Interactive comment on “Assessing the perturbations of the hydrogeological regime in sloping fens through roads” by Fabien Cochand et al.

Fabien Cochand et al.

Received and published: 25 February 2019

Fig. 1. Simulated groundwater velocities at observation point G depending on the slope, KS and KD

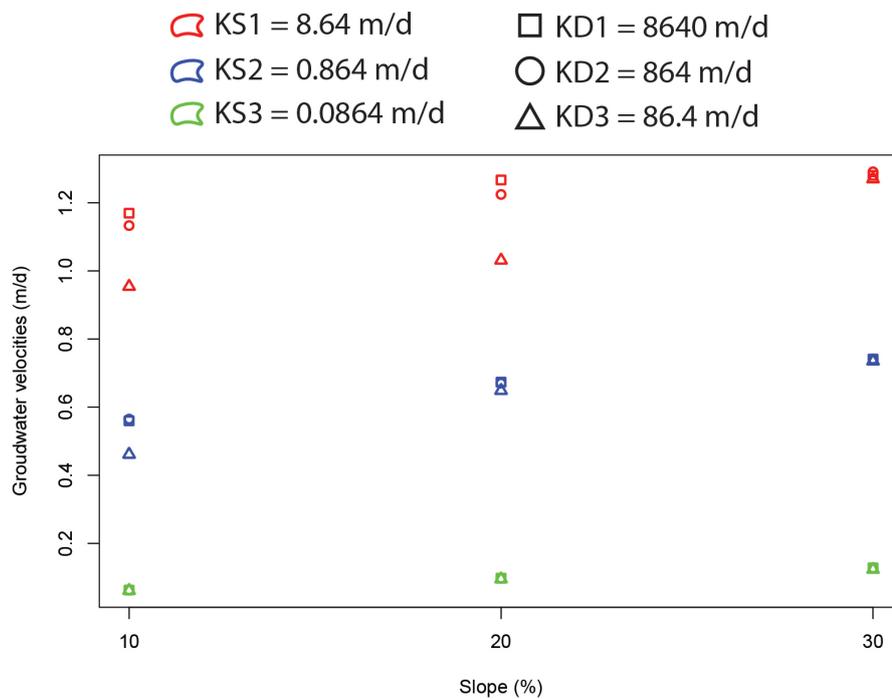
- 1) A graph in which groundwater velocities are presented according to the slope, KS and KD to clearly identified which parameters govern the fen dynamics (Figure 1 below).
- 2) Analysis of groundwater velocities downslope the road at different distances to assess the extent of perturbation induced by the I-drain (Figure 2 below). In this way, the water distribution downgradient of the L-shape structure is addressed (as suggested by reviewer 3)
- 3) Analysis of groundwater velocities upslope the road as suggested by reviewer 2 (Figure 3 below). In this way, the impact of the road in the upstream part of the fen is assessed.
